Project: LODI UNIFIED SCHOOL DISTRICT
BEAR CREEK HIGH SCHOOL RESTROOMS MODERNIZATION

ADDENDUM 1

10/26/2023

A11.1

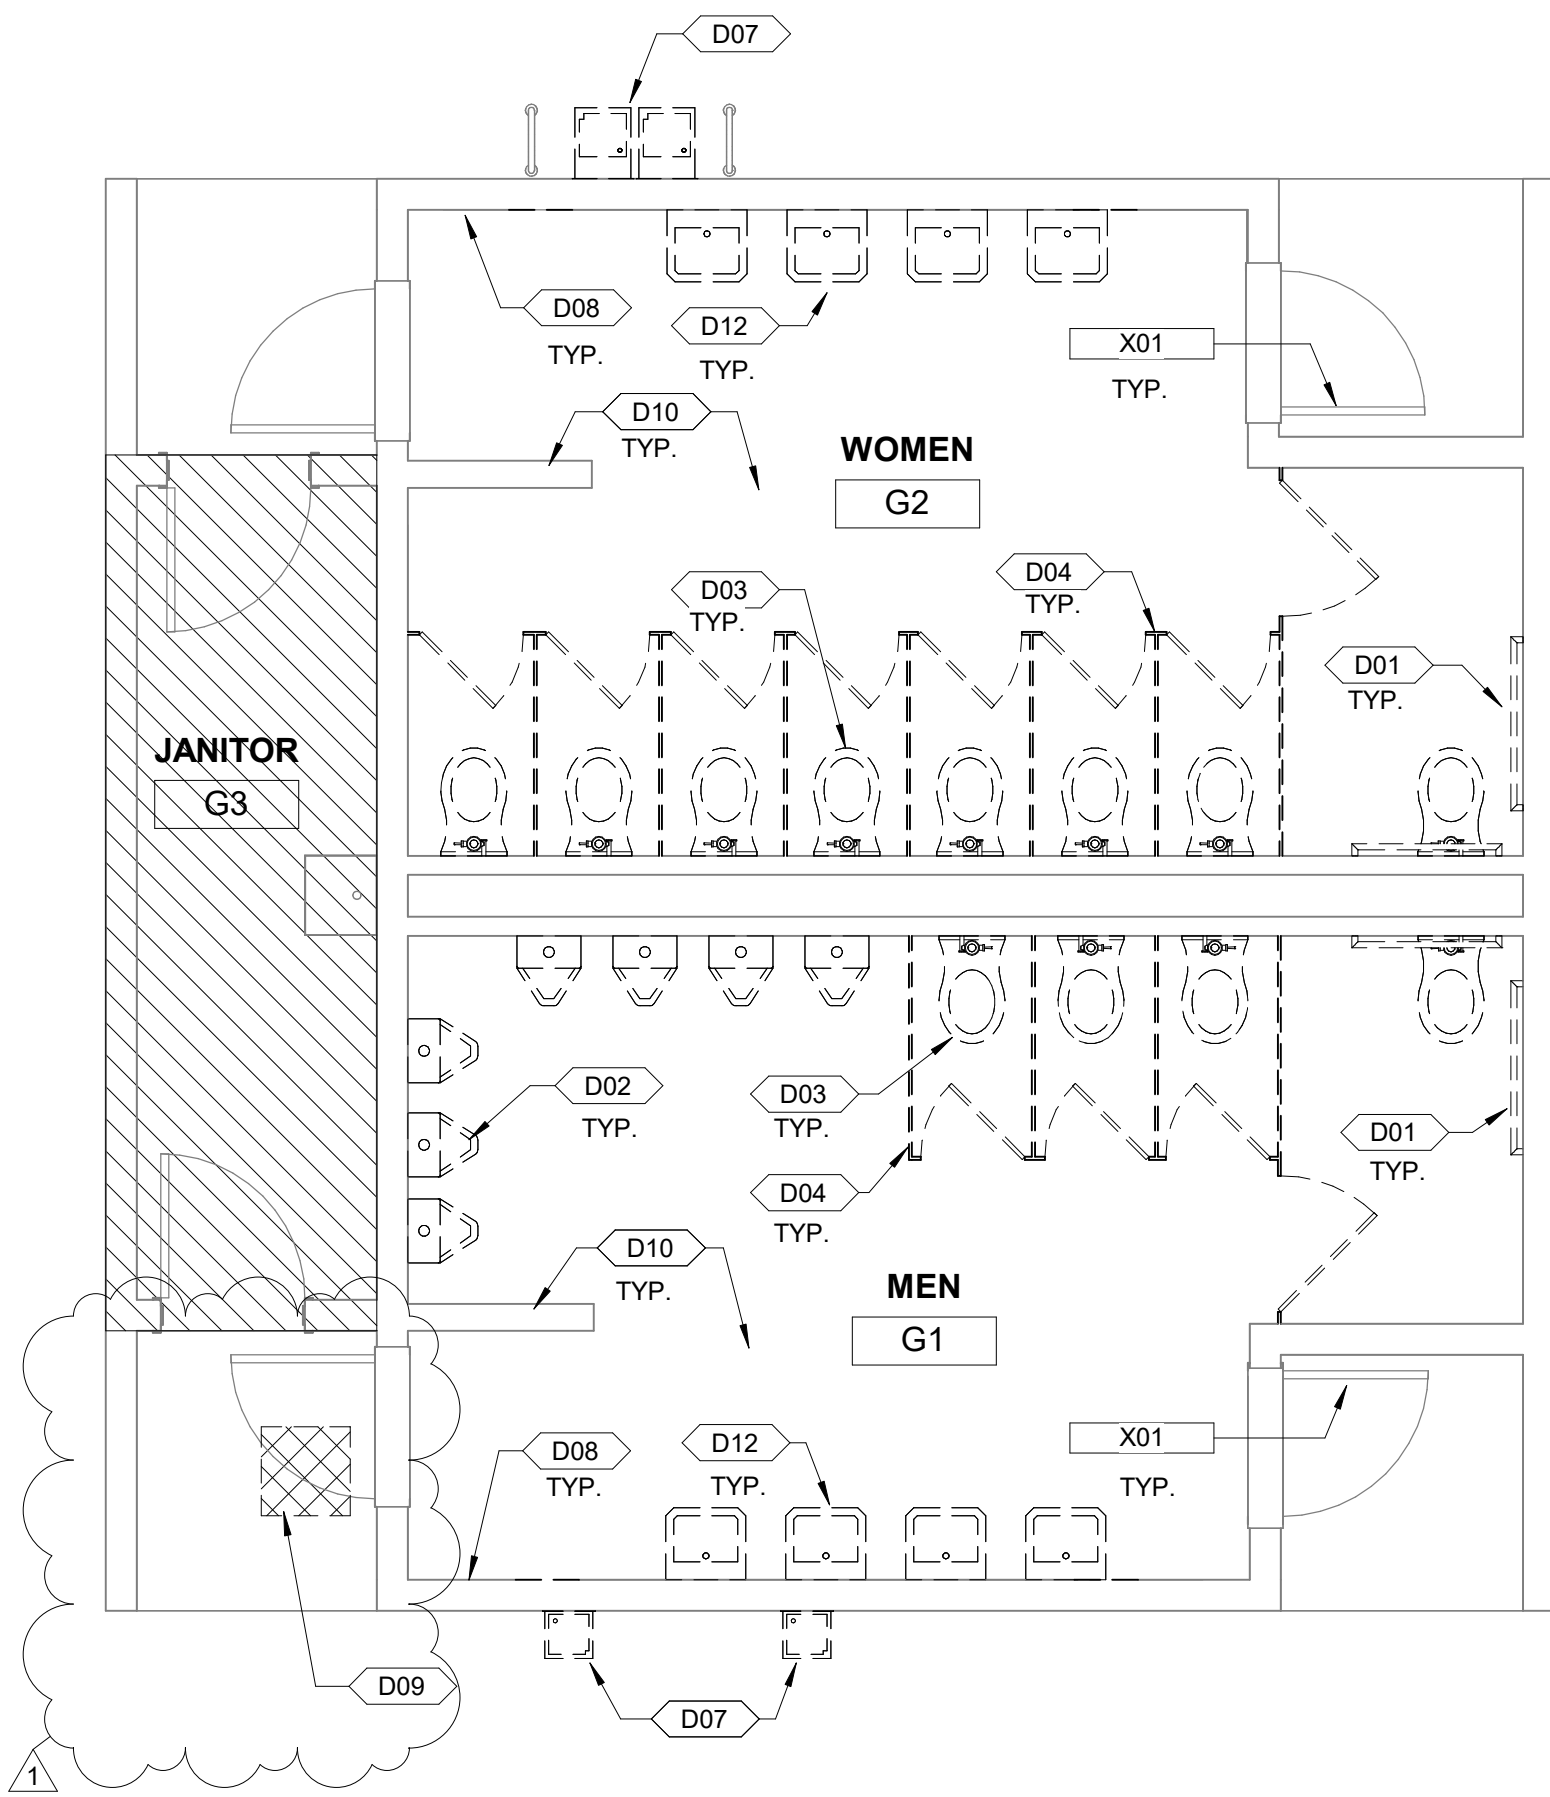
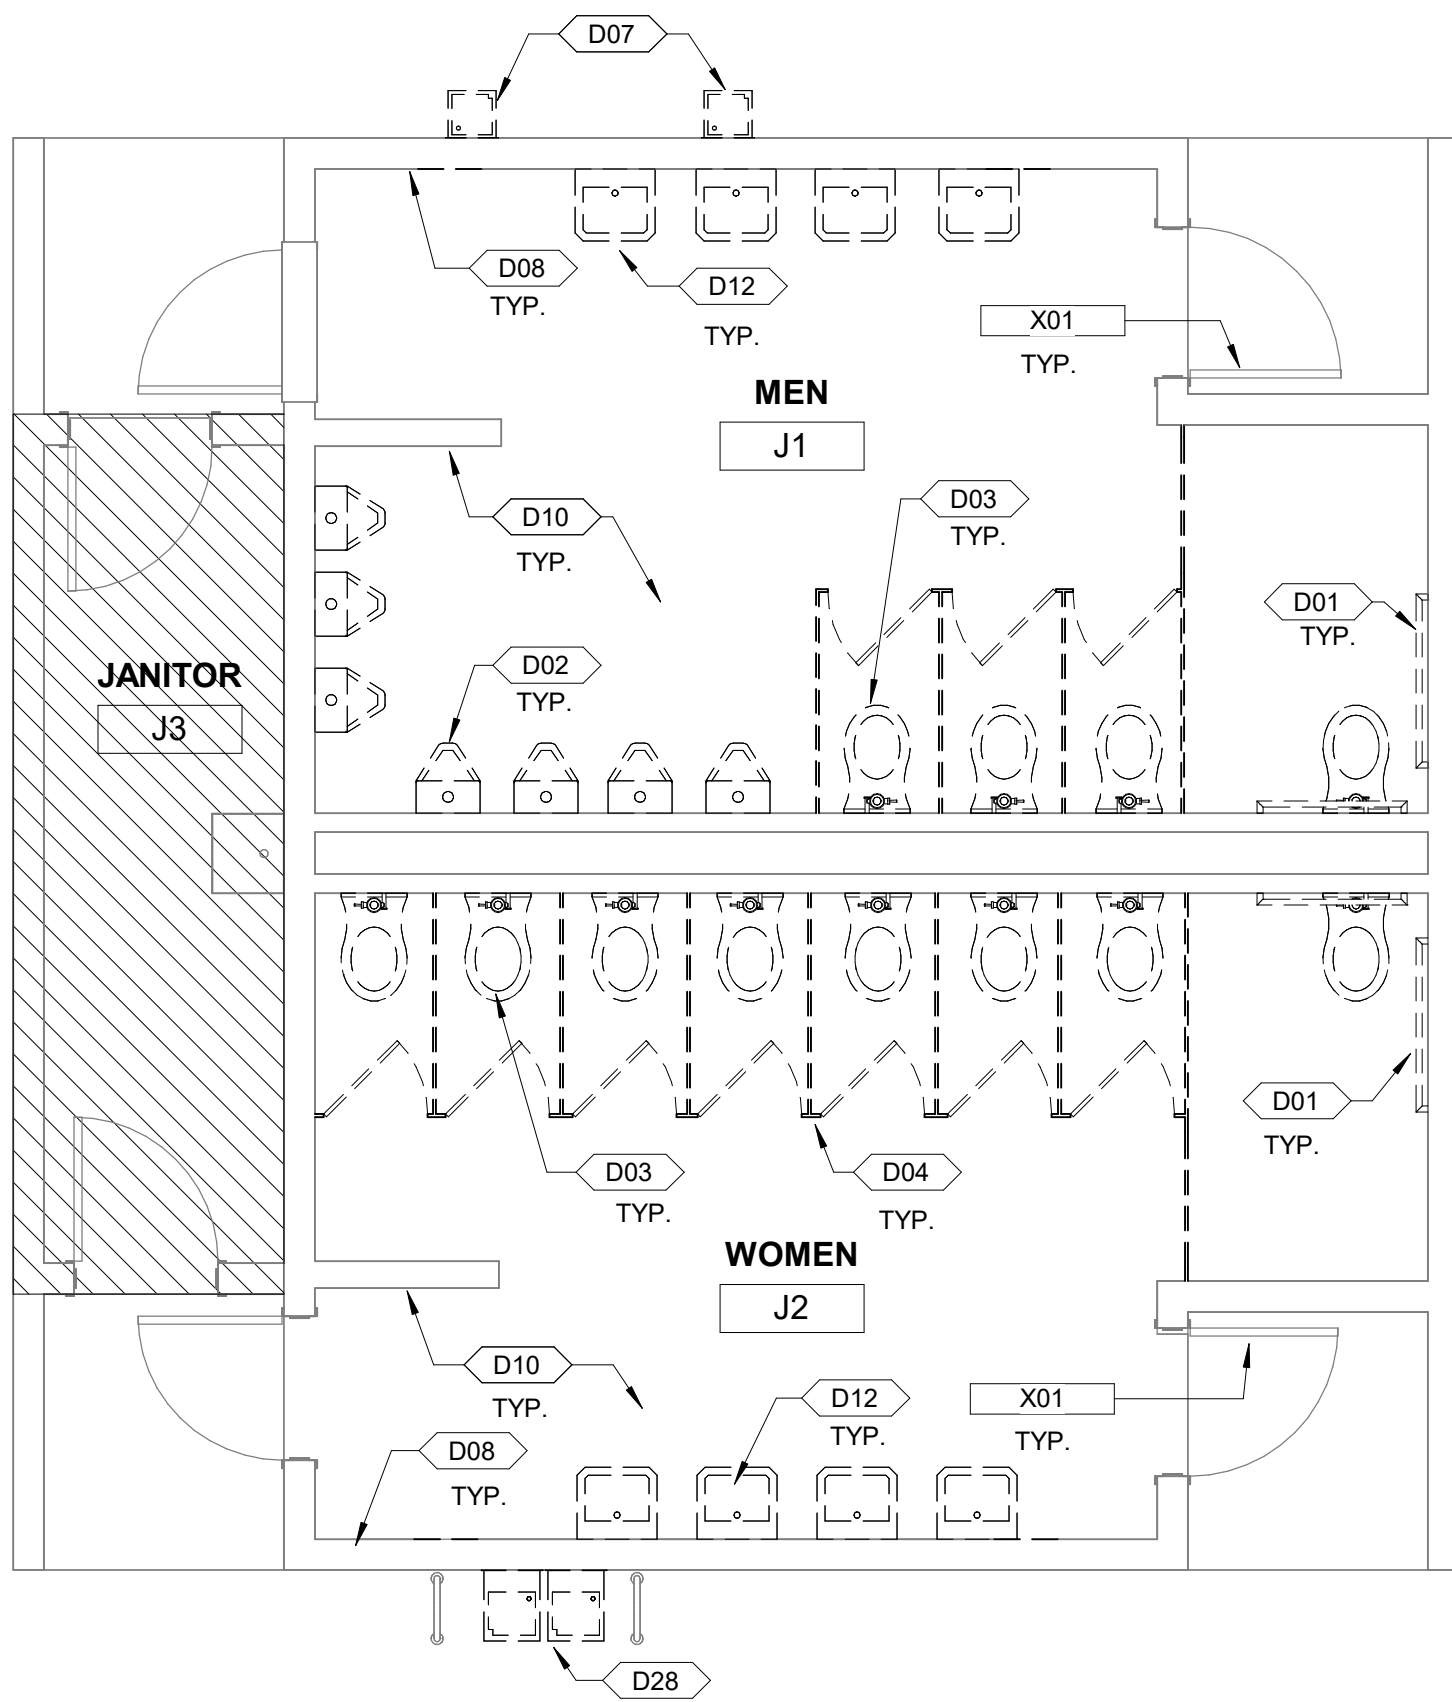
- A. A11.1: Demol Floor Plans
 - a. Revise concrete slab repair prep to chip out 12"x12"x1" deep area at damaged area
 - b. Revise keynote D09
- B. A40.1: Building G – Enlarged Plans & Interior Elevations

| D09 | CHIP OUT CONC. 12" X 12" AREA AT DAMAGED SLAB TO 1" DEEP AND PREP AS REQUIRED TO PATCH |
